### **OUR CLIENTS: MR RICHARD GILL, MRS LISA GILL & DRONE DEFENCE SERVICES LTD SUBMISSIONS FOR DEADLINE 5**

# Cauntton Lodge Farm, Norwell Woodhouse.

Landscape Technical Note including Residential Visual Amenity  
Assessment (RVAA)

## **Deadline 5 – Interested Party’s Response to the Applicant’s Position Statement (Annex 2)**

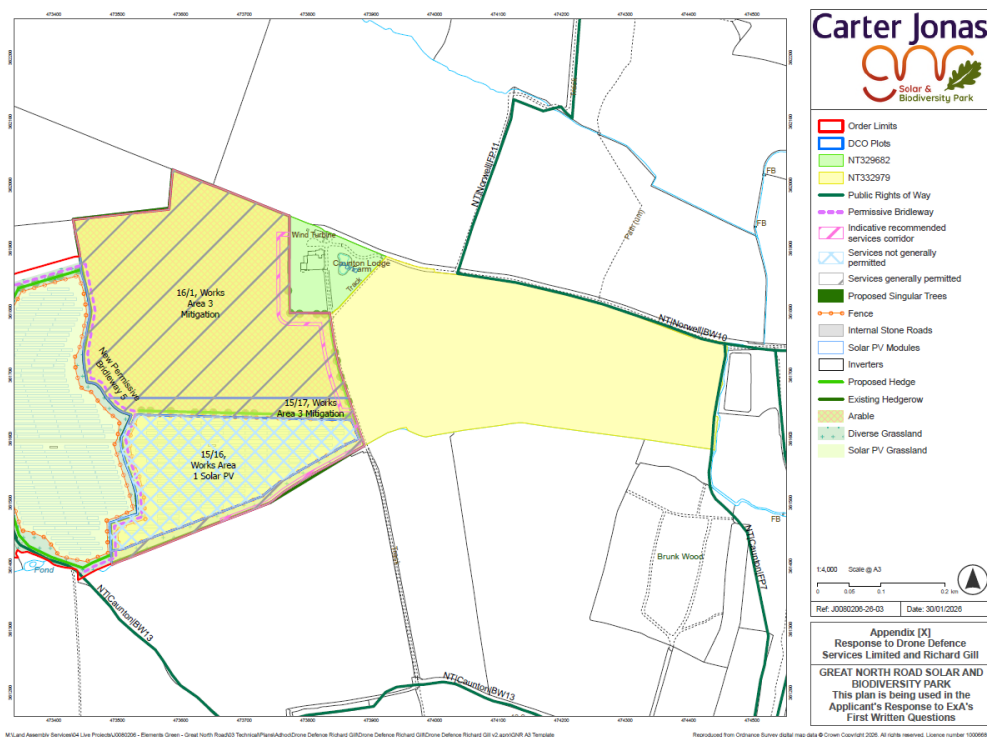
**2.4.1** With reference to Landscape Masterplan Figure 5.2 (5) of the GNR Solar & Biodiversity Park development, proposed solar arrays in areas W18.1 and W18.3 are to be located within a distance of 250 metres of the property. These are shown in the extract from the Landscape Masterplan below.

height to be seen in area W18.1, it is proposed area W18.3 that has the greatest potential to create a significant change to views from the property.

2.4.3 Landscape Masterplan Figure 5.2 (5) proposes a new hedgerow to be planted along the northern boundary of solar array area W18.3 where presently there is no field boundary with the remainder of the field which is proposed to be retained in arable agricultural land use.

2.4.6 It is assessed that development features such as solar arrays, boundary fencing and pole mounted CCTV will be generally visible in proposed development areas as follows:

- a. Ground floor west facing windows – Development areas W18.1 and W18.3
- b. Ground floor south facing windows – Development areas W18.1 and W18.3
- c. First floor south facing windows – Development Area W18.3
- d. Inner terrace garden – Development Area W18.3

- e. South lawn – Development Areas W18.1 and W18.3
- f. West lawn – Development Areas W18.1 and W18.3
- g. East lawn and arrival area – Development Area W18.3
- h. Driveway - Development Area W18.3

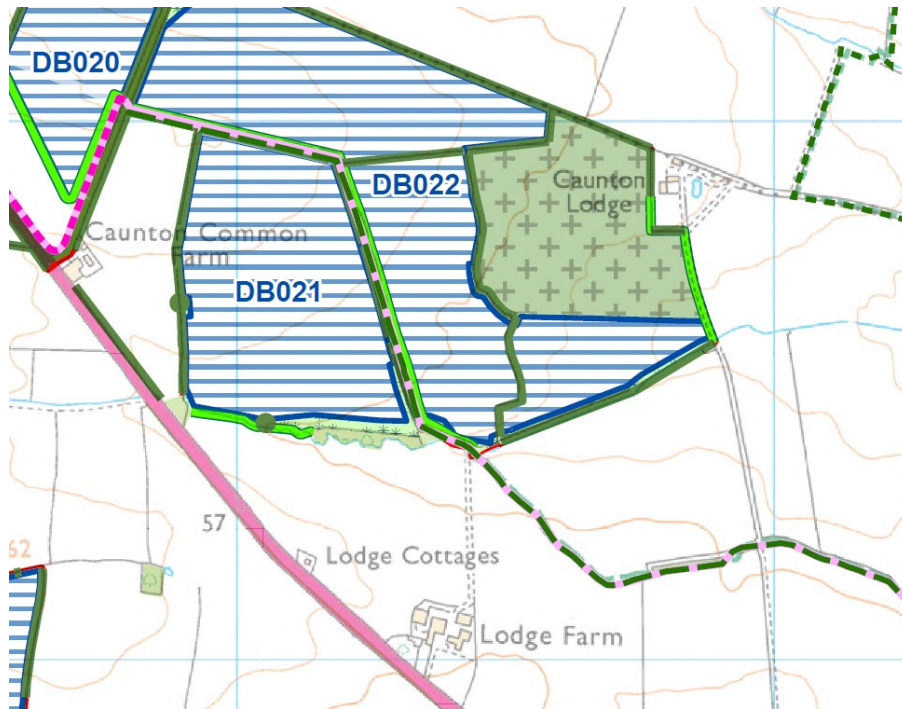
2.4.9 It is also noted that on the plan provided in response to Drone Defence Services Limited and Richard Gill, that new hedge and tree planting is proposed along the southern access track to Caunton Lodge Farm, along the southern boundary of the property and along part of the western boundary. The nature of this proposed mitigation is unclear in the key and could in its own right result in further loss of openness and views enjoyed by the property. The plan is reproduced below.

2.4.10 The above plan also identifies that walkers using the public right of way (Norwell FP11) located to the east of the property, will be visual receptors of development proposals within development area W18.3. Walkers heading west or south at the access drive to Caunton Lodge Farm will experience similar views to those accessing the property. This is confirmed in the Applicants LVIA where local footpath users identified as 'Group D Between Kneesall, Caunton and Ossington Airfield' are assessed to experience medium scale changes in views, resulting in **major/ moderate adverse and significant** effects.

### 5.2.1.2 Design Changes near Norwell Woodhouse

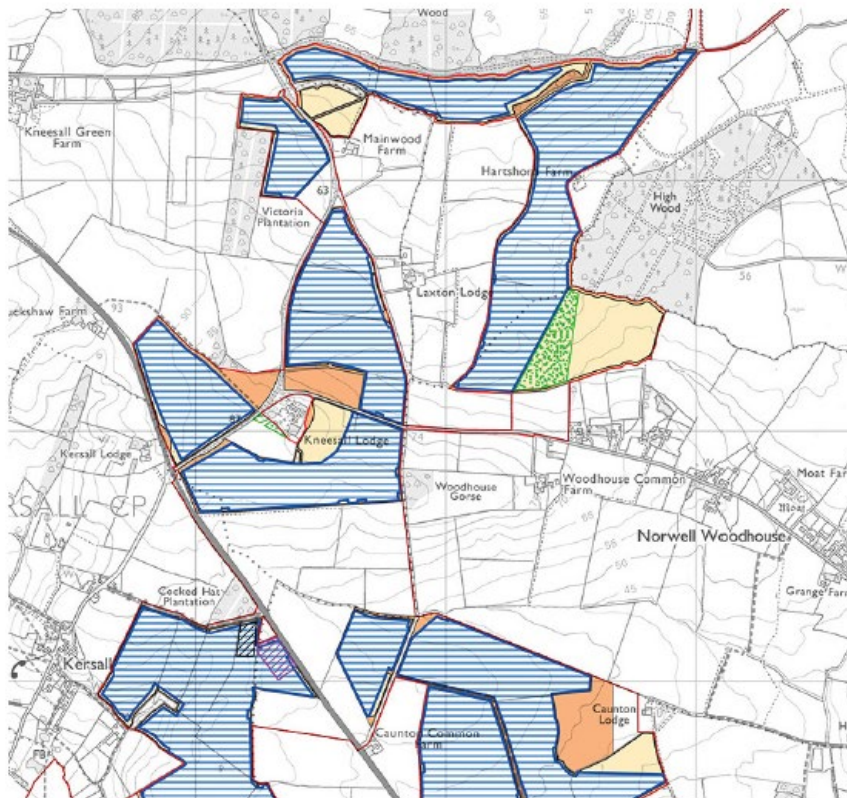
3.1.16 The Design Approach Document (EN010162/APP/5.6B) Revision 3 dated January 2026 sets out a number of examples where an iterative design approach has been used to address mitigation including relocation of solar arrays away from residential properties. The document presents the iterative design process that delivers the hierarchy of mitigation in accordance with EIA Regulations. Paragraph 5.2.1.2 Design Changes near Norwell Woodhouse records the process including the approach to mitigation at Caunton Lodge Farm. The extract below sets out the design actives which are illustrated on the plan extract.

- Removal of one of the two potential areas for the Lime Lane intermediate substation to reduce visibility from the A616.
- Removal of solar panels south of High Wood from slopes facing towards Norwell Woodhouse and new woodland in the area to screen panels further west.
- Further set back of solar area to south of property at Cauntun Lodge and removal of panel areas north of Mainwood Farm and east and southeast of Kneesall Lodge in response to comments from householders during consultation in relation to visual amenity.

3.1.17 It can be seen that when applied correctly, the approach to mitigation ‘avoids’ potential adverse effects such as predicted at Mainwood Farm and Kneesall Lodge. This was achieved through the removal of solar arrays originally proposed at scoping and preliminary masterplan stages. However, at Cauntun Lodge Farm the design was adjusted but this adjustment did not address the nature of the harm or reduce the level of harm to residential amenity to less than major adverse. Visual harm was not avoided even with the introduction of secondary mitigation measures including hedge and tree planting.
